Schedule 'C' Municipal Class Environmental Assessment for Upper  
Wellington Street between Stone Church Road and Limeridge Road, City of  
Hamilton, Ontario

# Public Information Centre #1 Summary Report

**Table 5-1: Summary of PIC #1 Comments and Study Team's Responses**

## Segment 1: Upper Wellington St between Stone Church Rd and Towercrest Dr / Sirente Dr

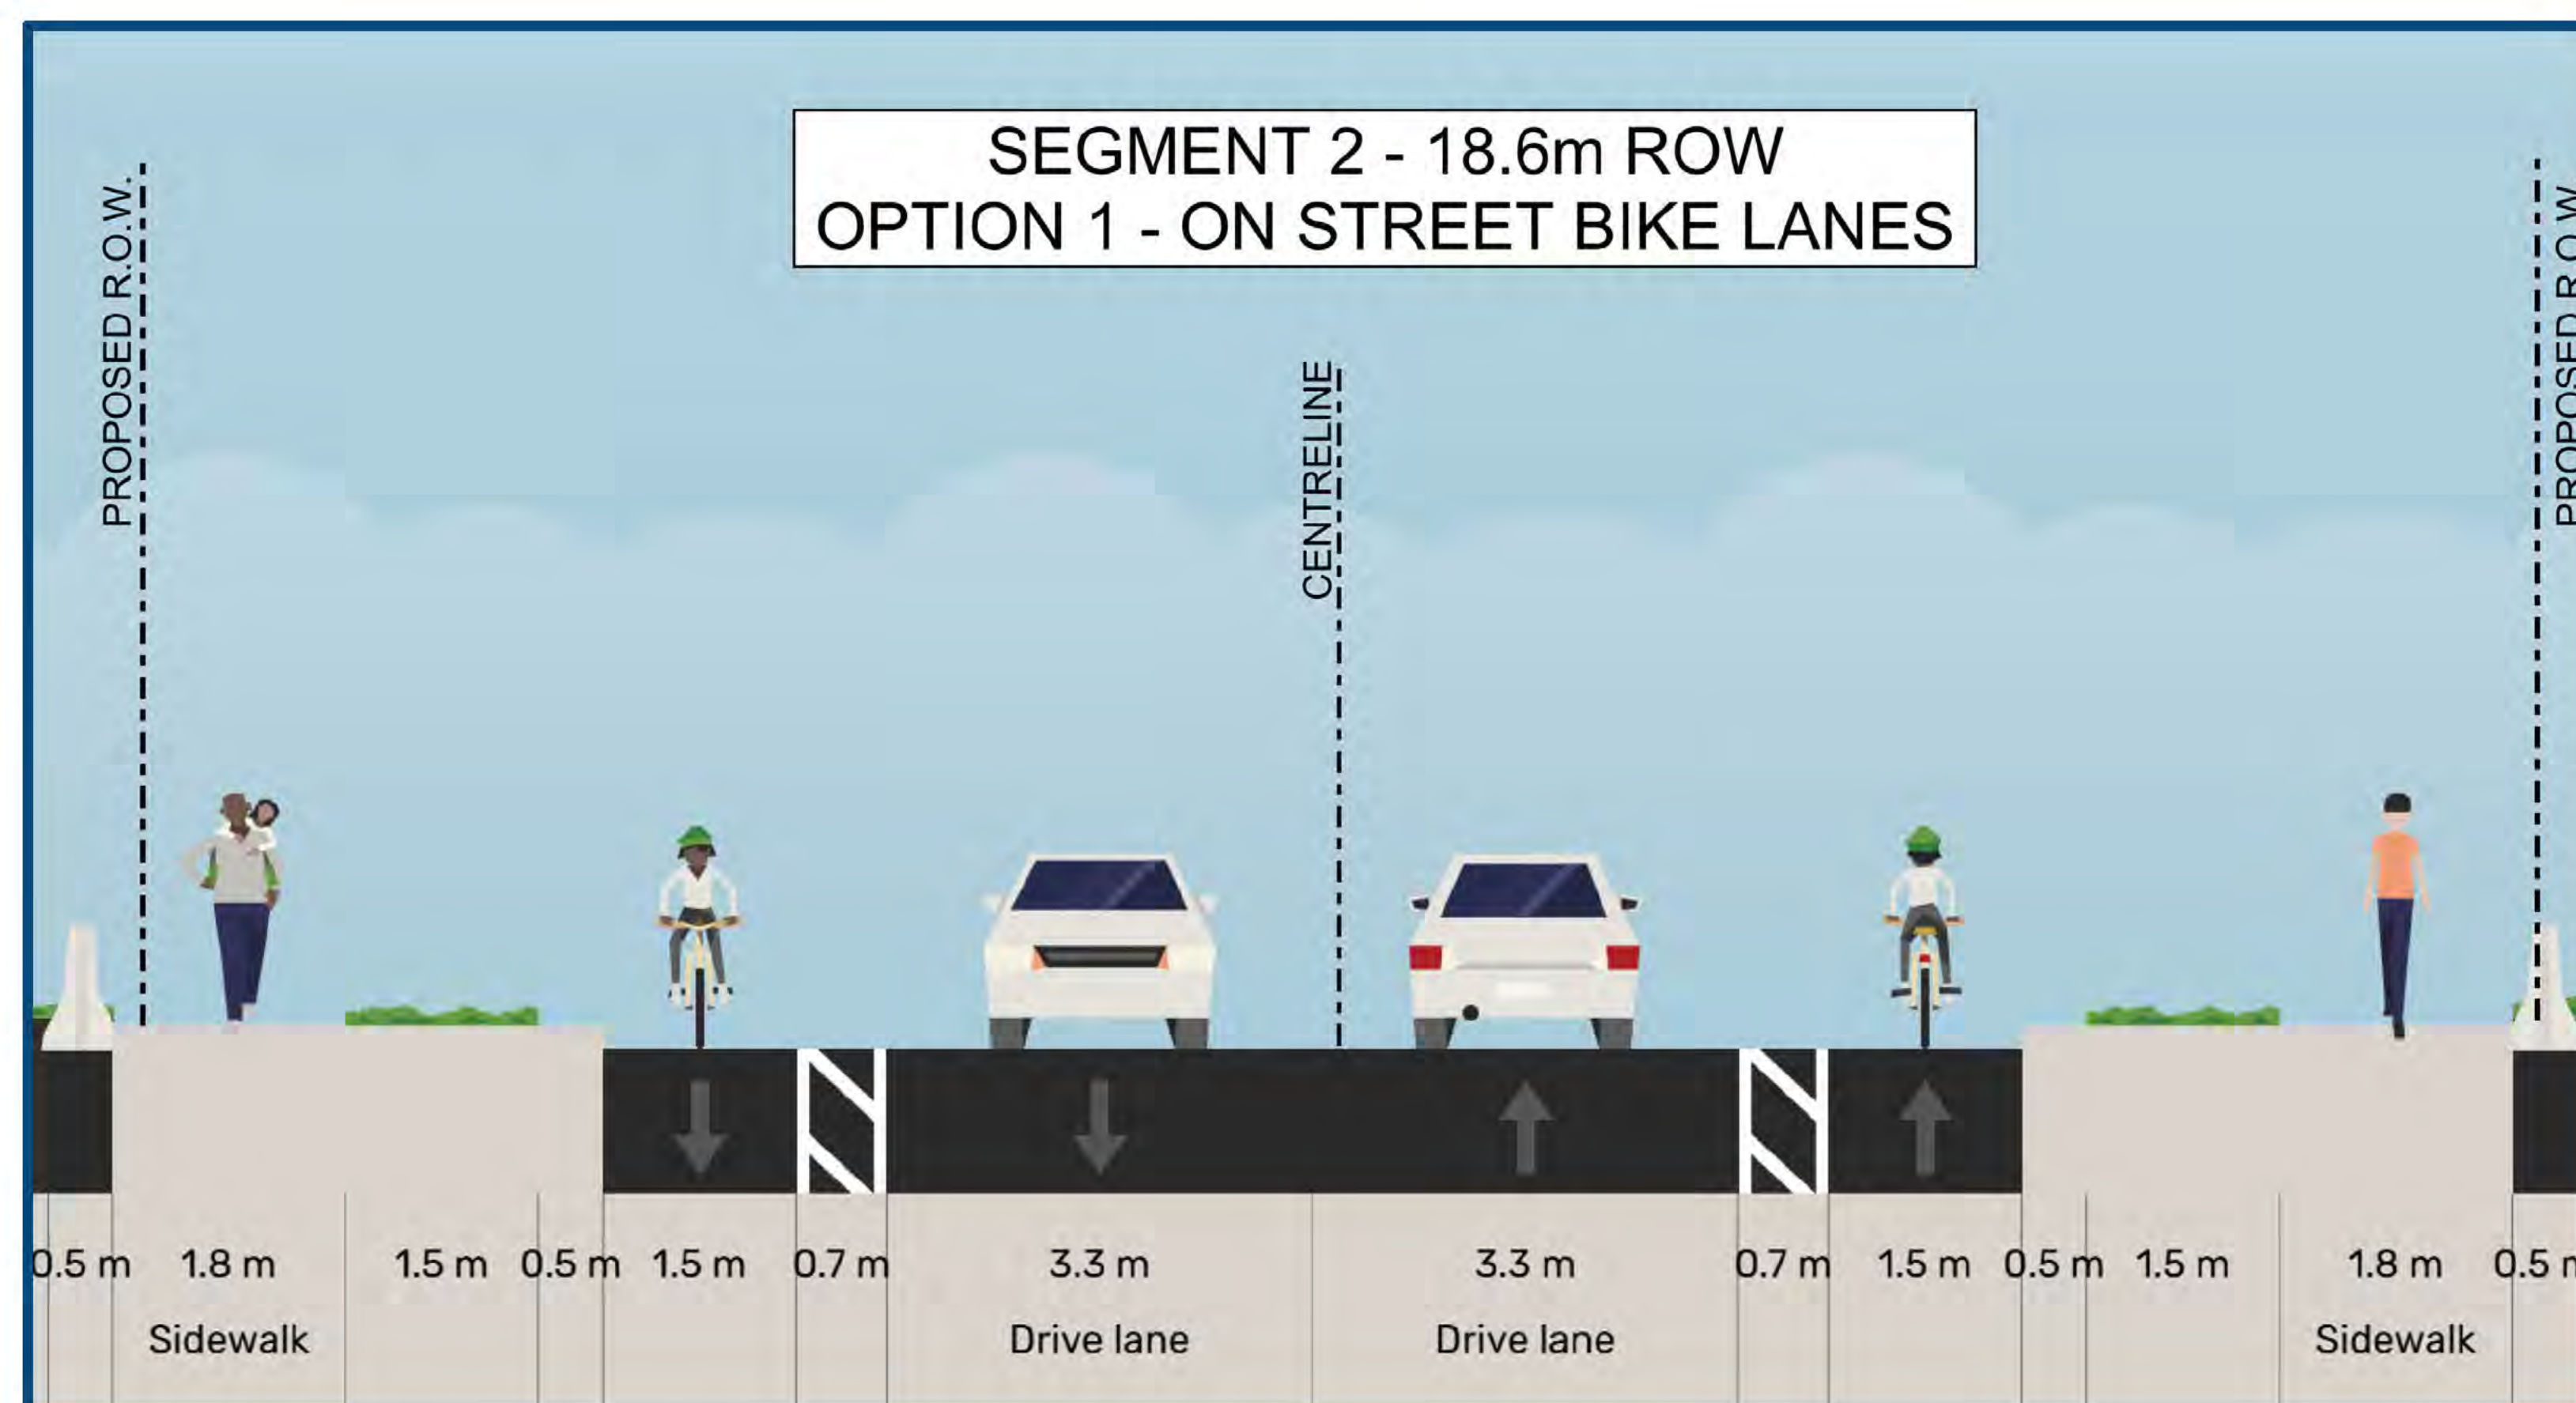
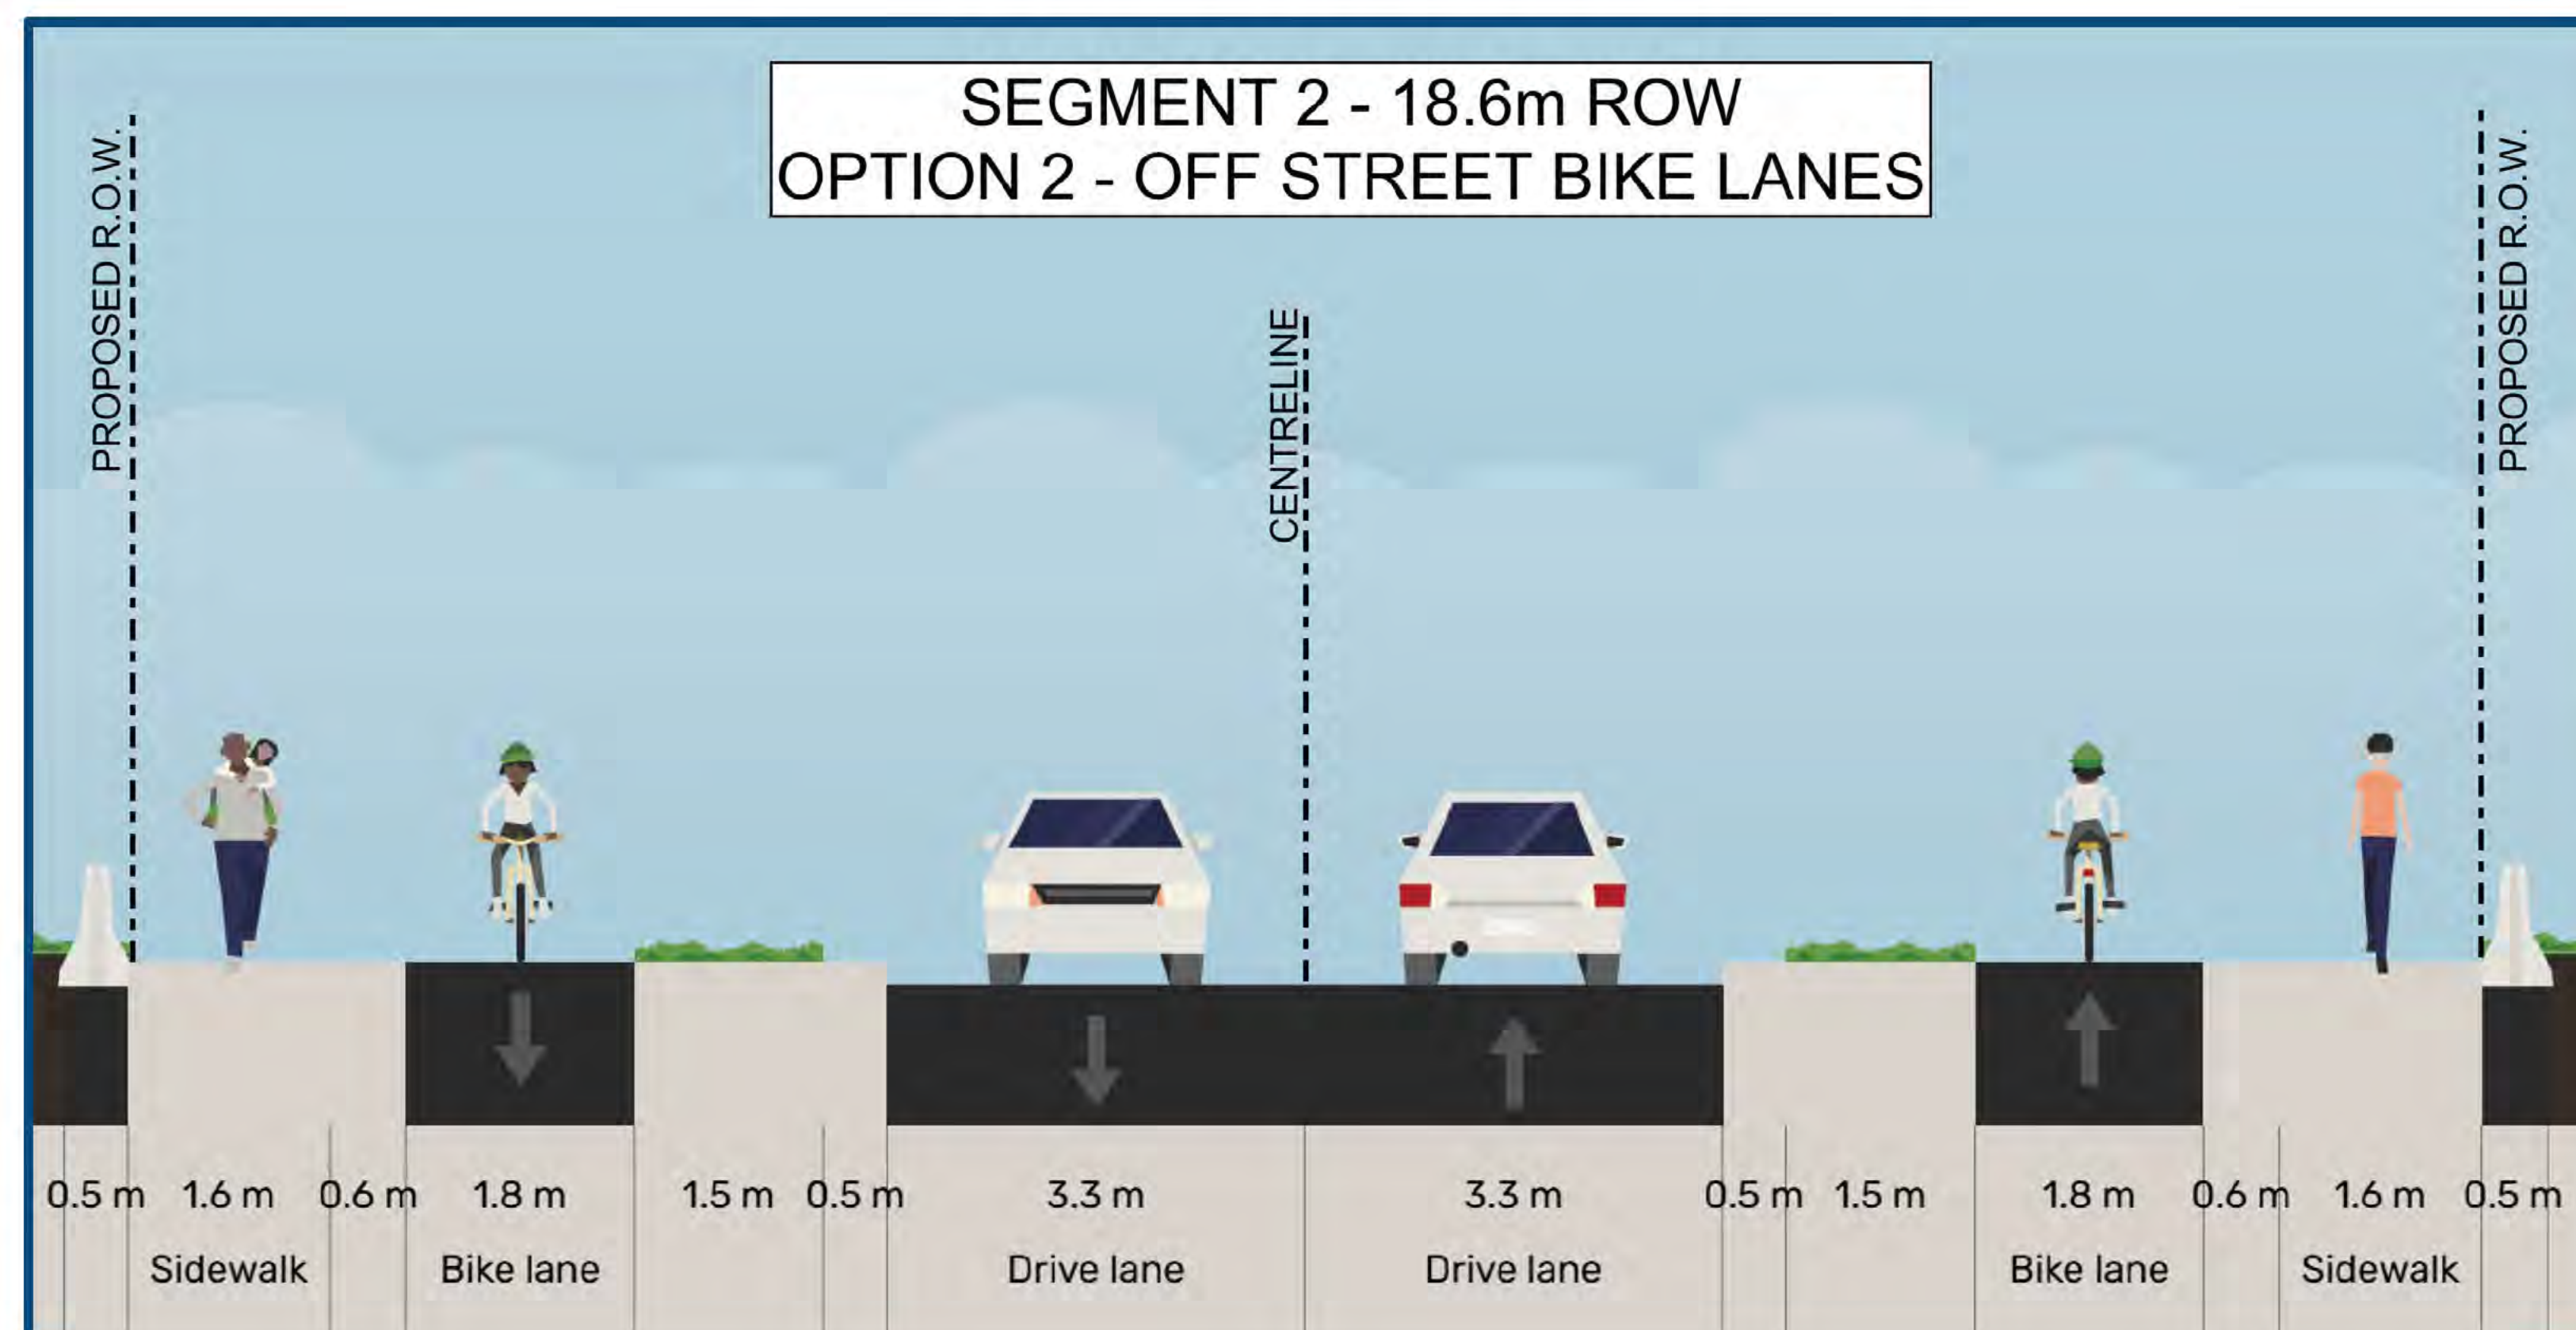
my comment (suggestion) has to do  
with the planting strip (buffer)  
on both side of Upper Wellington  
Ave. Stonechurch Rd & Towercrest/Sunrise  
I don't think that these planting strips  
are necessary. By eliminating the  
planting strips the city will save  
tax dollars. Grass and/or trees  
will not have to be maintained/repaired or  
replaced. at a cost to the city (its taxpayers)  
I've seen many examples of grass.

I would much prefer the City choose Roll Plan Option 1 with on street bike lanes. This would be considerably cheaper than Option 2. It would match with the south end of Upper Wellington. It is safe enough and much safer than what I ride now dodging power poles on the gravel beside the pavement.
